The Commission has issued the enclosed Amendment No. 72 to Facility Operating License No. DPR-35 for the Pilgrim Nuclear Power Station. This amendment consists of changes to the Technical Specifications in response to your application dated May 31, 1983.

These changes to the Technical Specifications expand the operating region of Pilgrim's power/flow map, and provide associated changes in the Average Power Range Monitor (APRM) flux scram and APRM rod block trip settings.

Amendment No. 72  
License No. DPR-35

SAFETY EVALUATION BY THE OFFICE OF NUCLEAR REACTOR REGULATION  
SUPPORTING AMENDMENT NO. 72 TO FACILITY OPERATING LICENSE NO. DPR-35  
BOSTON EDISON COMPANY  
PILGRIM NUCLEAR POWER STATION  
DOCKET NO. 50-293

Figure 2.1.1

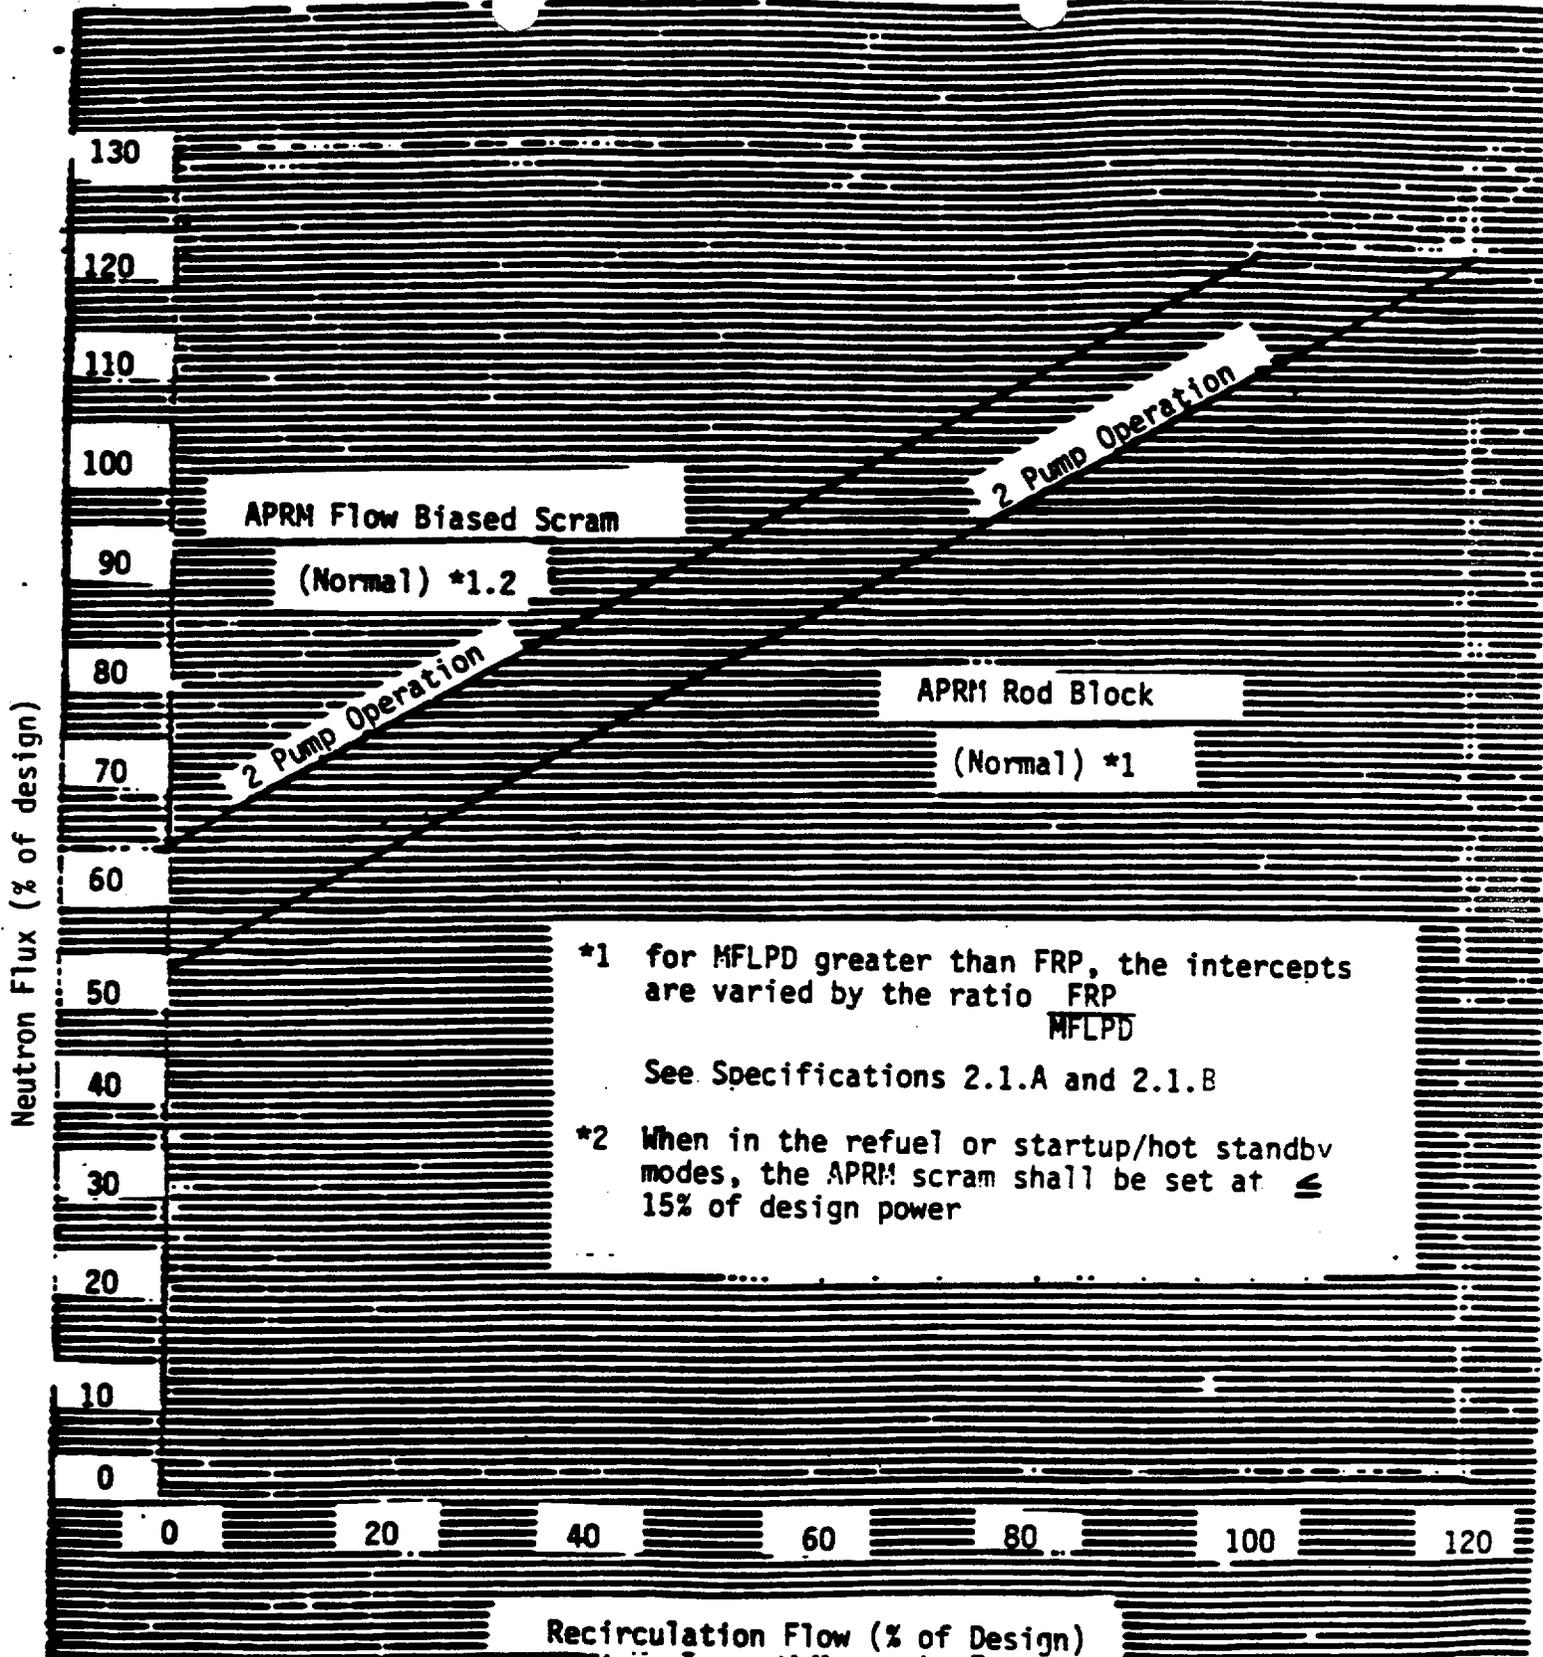
Table 3.2.C, Sections 2.1.A and 2.1.B and Figures 2.1.1 and 3.11-9 of the proposed Technical Specifications have been modified to include the extended operating power/flow map given in Figure 1.1 of reference 2. The modifications include the changes of the APRM rod block and trip set points from 0.65 W + 42% to 0.58 W + 50%, and 0.65 W + 55% to 0.58 W and 62% respectively, where W is the loop recirculation flow as a percentage of the loop recirculation flow which produced a rated core flow of 69 million lbs/hr.

$$S \leq .58W + 62\% \text{ 2 loop}$$

$$S_{RB} \leq 0.58W + 50\% \underline{2 \text{ Loop}}$$
